A UPGRADE  
Report

**TAX ID #**  
**ON-SITE SEWAGE DISPOSAL SYSTEM**  
**HOWARD COUNTY HEALTH DEPARTMENT**  
**BUREAU OF ENVIRONMENTAL HEALTH**

SUBDIVISION: Hyde Property LOT NUMBER: 5

ADDRESS: 12296 Hydeaway Court PROPERTY OWNER: Jeffrey Dance

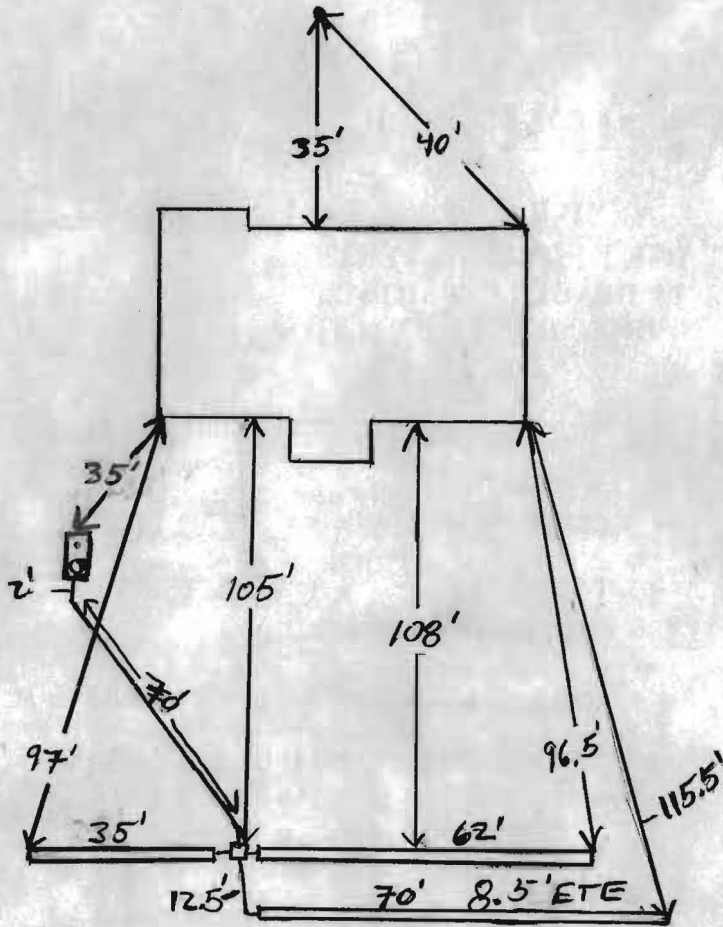
TRENCHES:	Trench to be <sup>3</sup> feet wide. Inlet <sup>4</sup> feet below original grade. Bottom maximum depth <u>5.5</u> feet below original grade. Effective area begins at <u>4</u> feet below original grade. <u>1.5</u> feet of stone below distribution pipe.
LOCATION:	* system needs repair not upgrade. Filled system. 10/12/06
NOTES:	↪ To relocate septic trench in support of building permit for pool. Abandon one 70' trench closest to house. And move it behind other 70' trench.

PRE-CONSTRUCTION 10/16/06 To install 160' of trench. Run two 80' trenches on contour towards right lot line. Inlet @ 5.5' bottom @ 8.5'. Trenches to be 2' wide.

10/18/06 System installed. Contractor had to stop short on first trench because of right lot lines. Run 35' trench opposite 62' trench. Soil looked good below 5.5' on 35' trench. System O.K. to backfill. (KW)

1" = 30'  
pool site plan

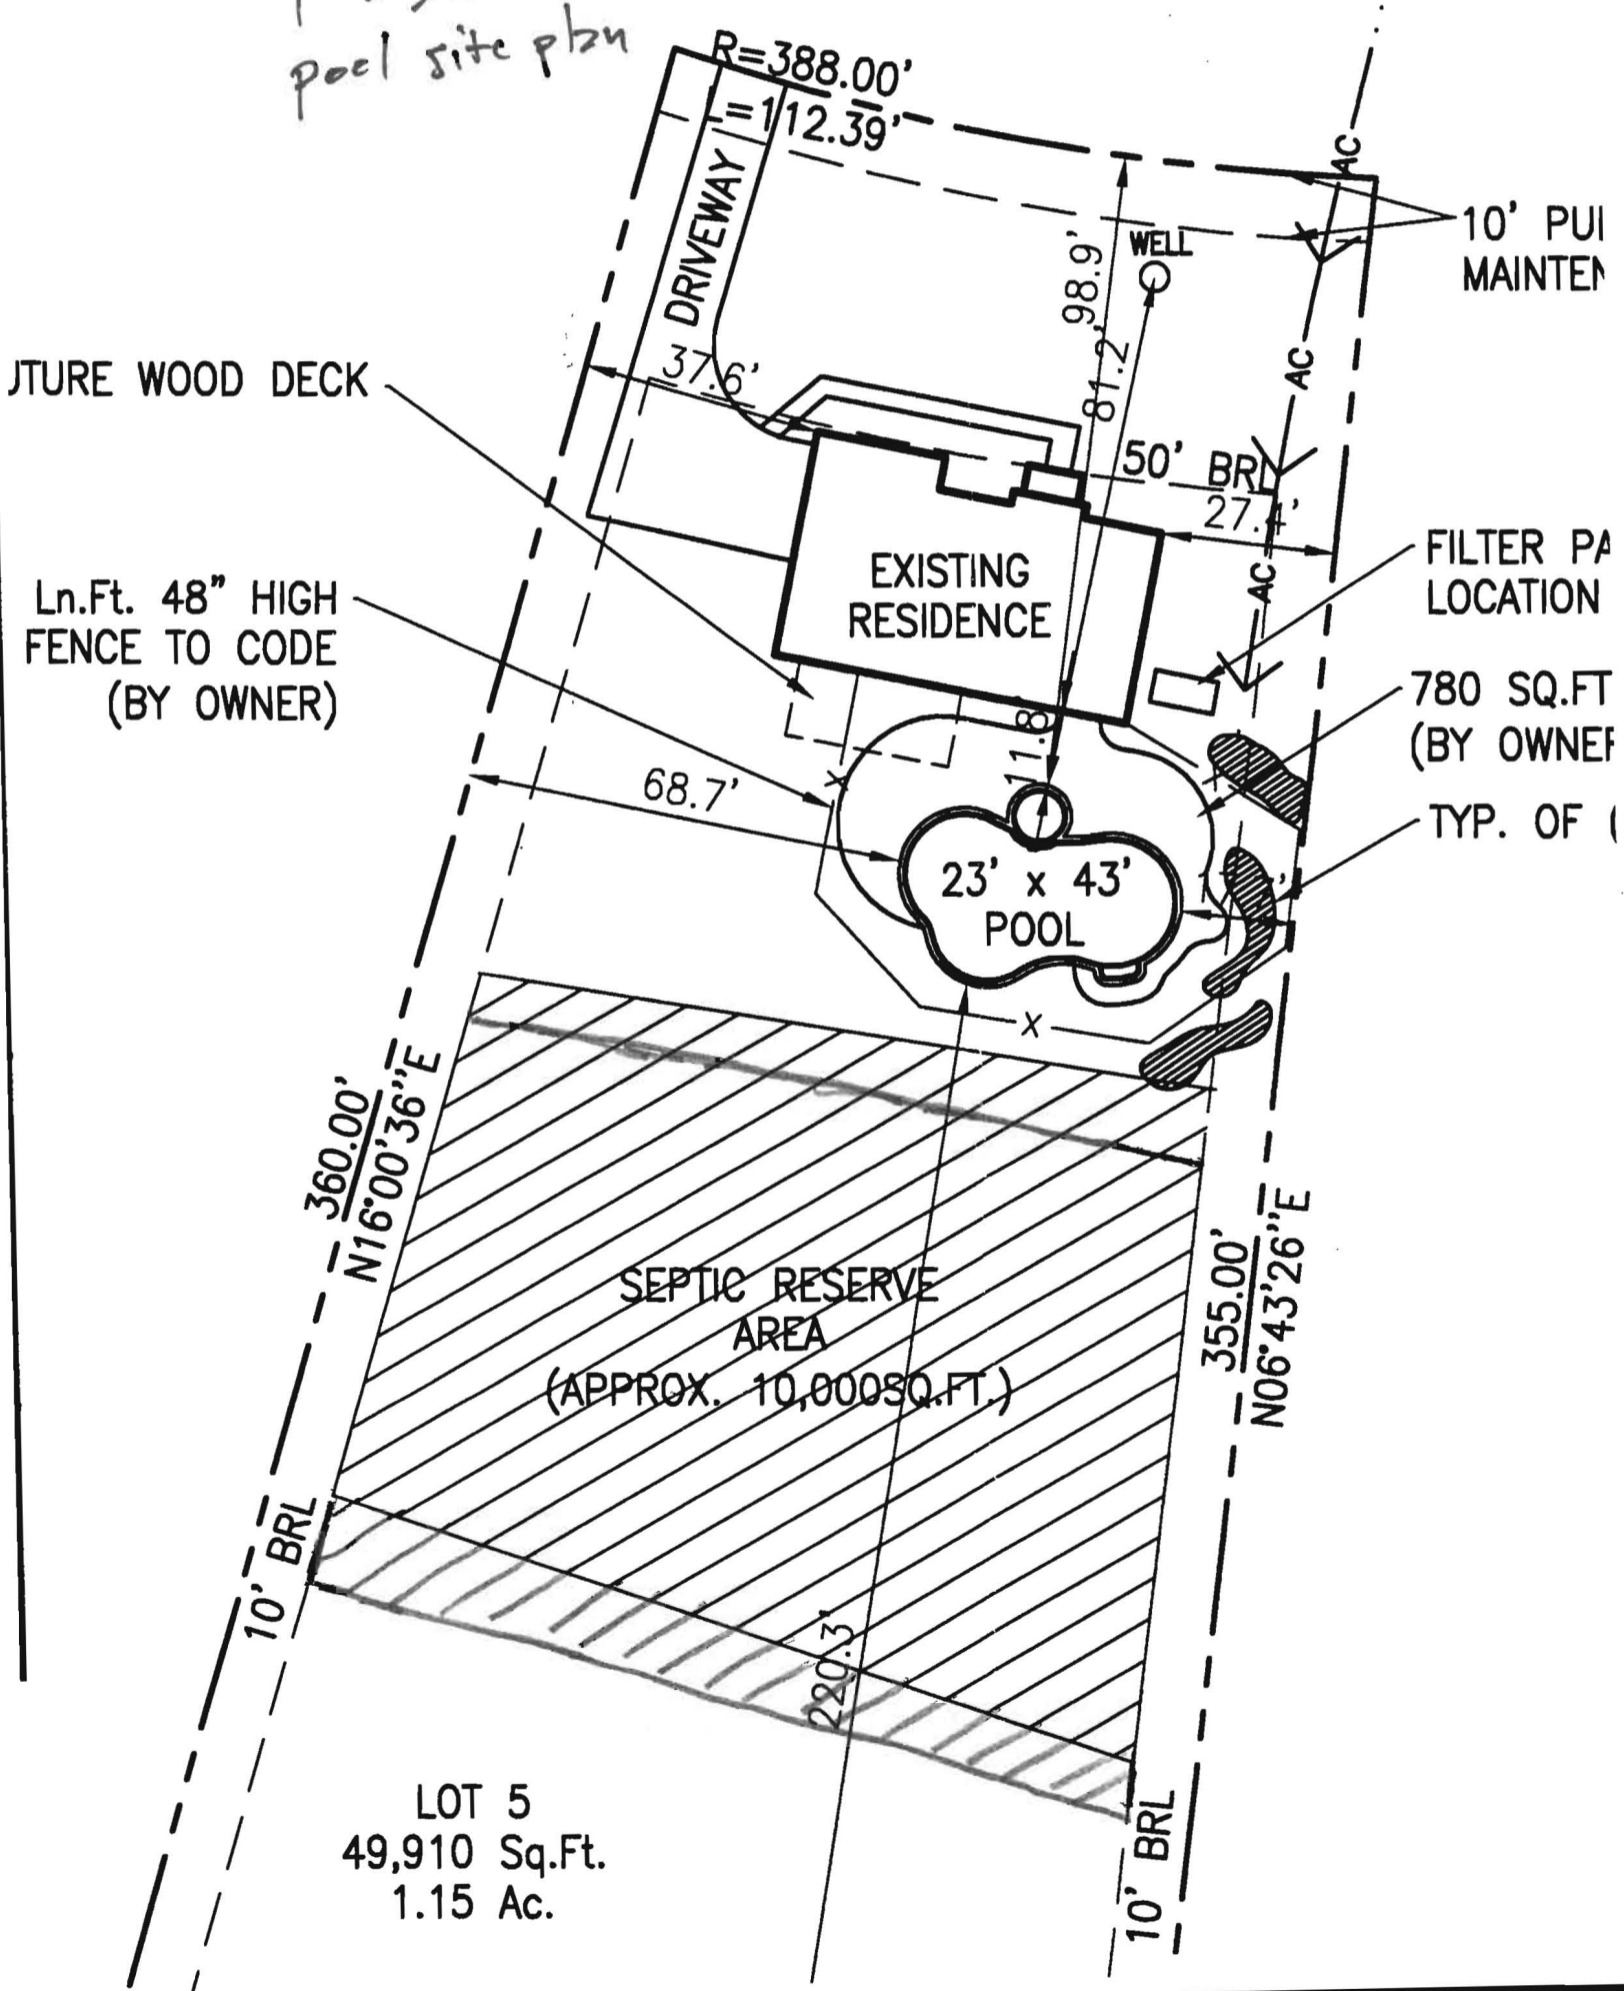
11/29/06  
Pool BP approved
